**COUNTY OF SAN MATEO
PLANNING AND BUILDING DEPARTMENT**

SUBJECT: EXECUTIVE SUMMARY: Consideration of a Design Review Permit, Coastal Development Permit, Non-Conforming Use Permit, and Grading Permit, to allow construction of a new two-story, 1,590 sq. ft. single-family residence with an attached 418 sq. ft. garage and 800 sq. ft. Accessory Dwelling Unit (ADU), on a legal 4,800 sq. ft. non-conforming parcel, in the unincorporated Miramar area of San Mateo County. The use permit is required to allow development on a less than 5,000 sq. ft. parcel, where 10,000 sq. ft. is the minimum lot size in the S-94 Zoning District and to allow reduced side setbacks of 5 feet 3.5 inches where 10 feet is required. The project involves 290 c.y. of earthwork and approximately 73 feet road extension of Alto Avenue. The project is not appealable to the California Coastal Commission. In conjunction with the requested permits, it is recommended that the Planning Commission determine that the project is categorically exempt from California Environmental Quality Act (CEQA) pursuant to CEQA Guidelines Section 15303.

County File Number: PLN 2021-00101 (McGregor)

1 SOUTHWEST ELEVATION
SCALE: 1/4" = 1'-0"

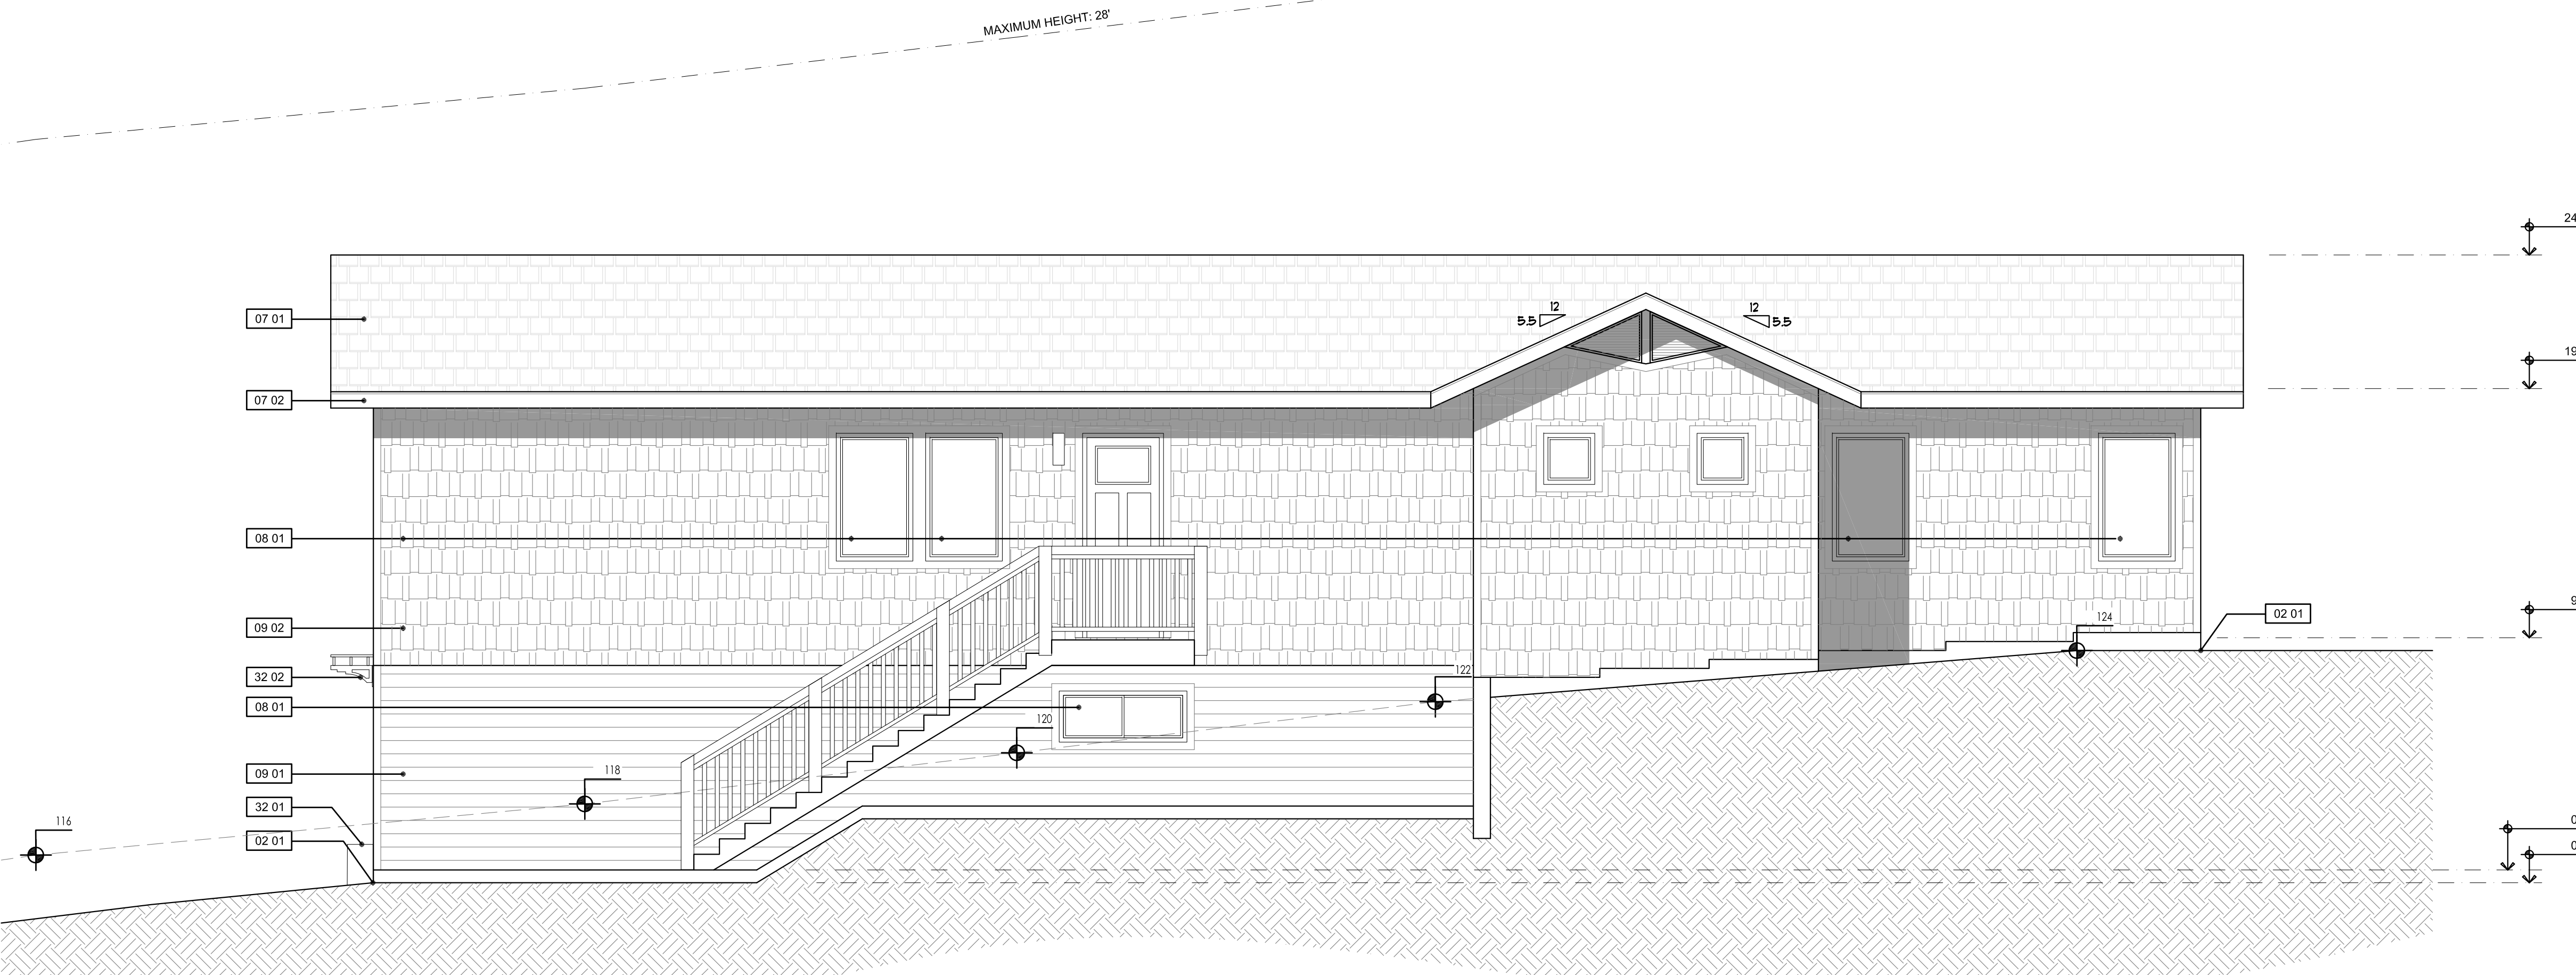
- e. Eliminate window in laundry room on southwest elevation, add two 2 feet by 2 feet windows, which are symmetrical about the southwest gable ridge, whose heads heights match the window head height of the other windows on the second floor.

2 SOUTHEAST ELEVATION
SCALE: 1/4" = 1'-0"

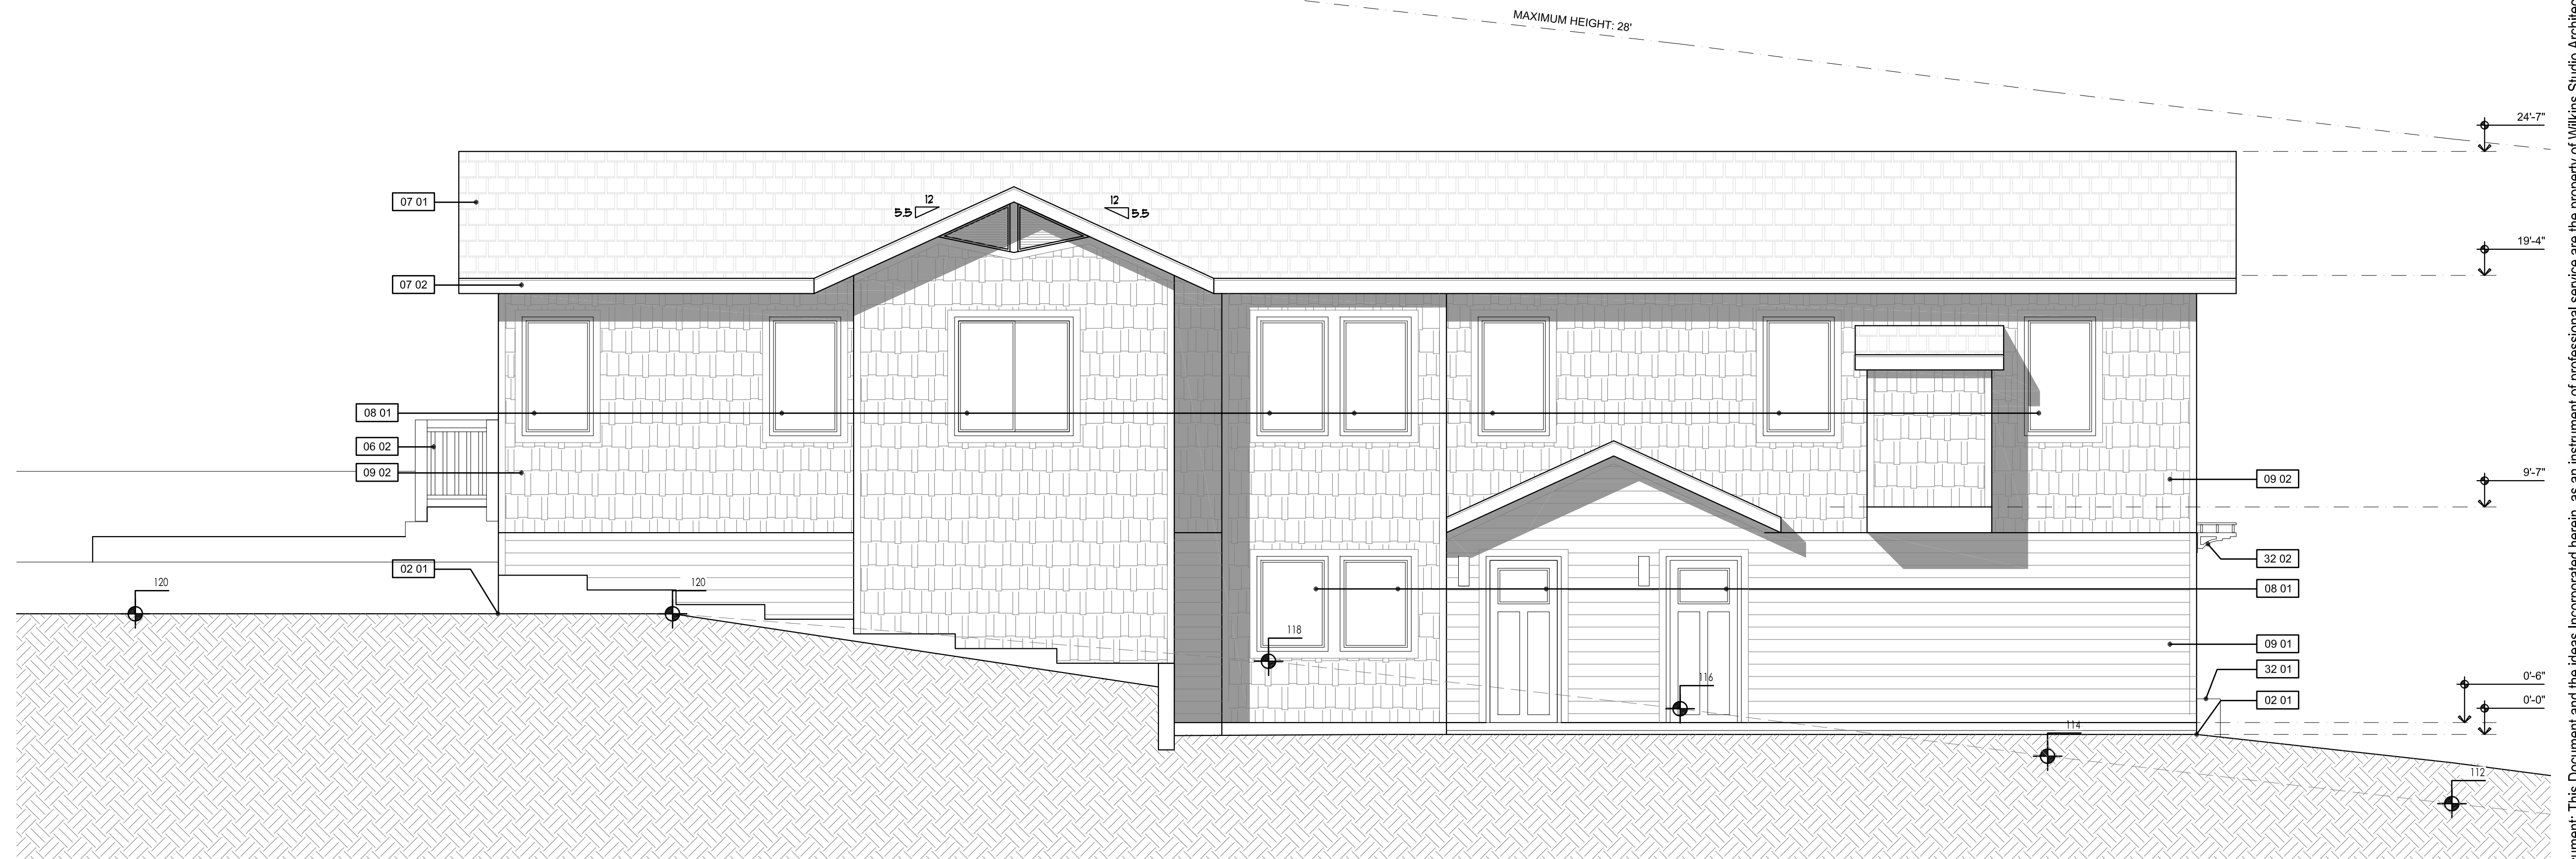
- b. Remove grids and bottom row from windows above the garage at the southeast elevation. Coordinate sill height with kitchen counter.
 - c. Use Craftsmen or shaker style for doors and garage door.
